APPLICATION NO.	FILING DATE	FIRST NAMED INVENTOR	ATTORNEY DOCKET NO.	CONFIRMATION NO.
10/643,862	08/19/2003	Michael J. Puglia	017191.0036 (MSA-3459)	5515
7590 Bayer Healthcare LLC 511 Benedict Avenue Tarrytown, NY 10591		08/08/2007	EXAMINER SOOHOO, TONY GLEN	
			ART UNIT 1723	PAPER NUMBER
			MAIL DATE 08/08/2007	DELIVERY MODE PAPER

Office Action Summary	Application No. 10/643,862	Applicant(s) PUGIA ET AL.	
	Examiner Tony G. Soohoo	Art Unit 1723

DETAILED ACTION

FIG. 15A

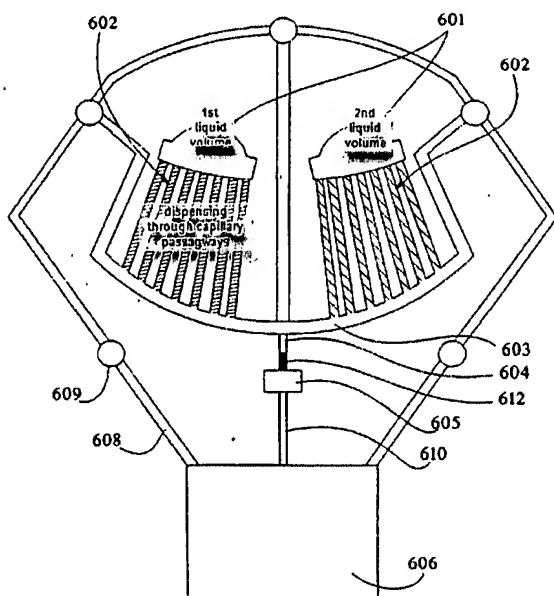
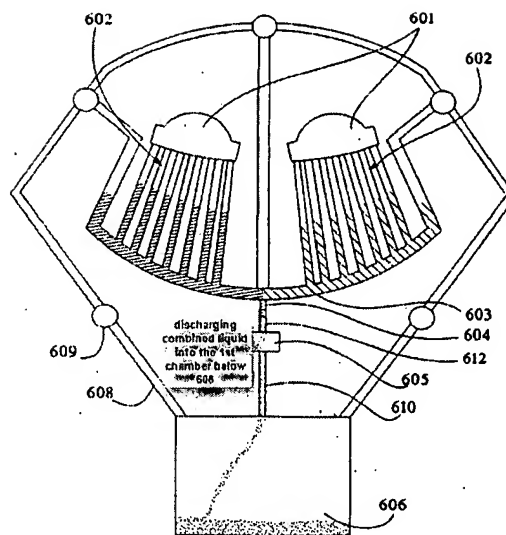
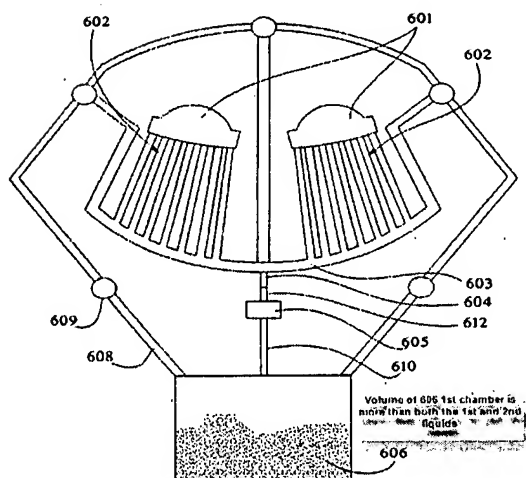
into a 1st chamber 605, 610, 606 whereby 605 is an assisting microstructure stepped wall structure to assist in mixing (claims 17, 37), and, as clearly seen provides

a volume which is much larger than the volume dispensed through the wells and capillary 601, 602 as seen in figure 15d. See Markup on the following page(s).

Also, applicant alleges in the remarks of 5/17/2007 on pages 12-13 that a calculation that of the chamber volumes of 606 is $18.75\ \mu\text{L}$ and 605 is $3\ \mu\text{L}$. The 1st chamber as defined by the Office is 605 ($3\ \mu\text{L}$) plus 606 ($18.75\ \mu\text{L}$) plus 610 (unknown). Addition of the volumes would yield at ($3+18.75+\text{unknown volume}=\text{}$) at least $21.75\ \mu\text{L}$. Thus with regards to the structure in an operation of the total of 1st and 2nd liquid volumes being between $2\ \mu\text{L}$ to $21.75\ \mu\text{L}$, the structure of the 1st chamber would have a volume large than the 1st and 2nd combined liquid volumes.

and discharged into the 1st chamber 605, 610, 606 which has a volume of $18.75\ \mu\text{L}$ which is a volume greater than the sum ($2\ \mu\text{L}$) of the predetermined volumes and would result in free space within the chamber in relation to the level of fluid in the chamber.
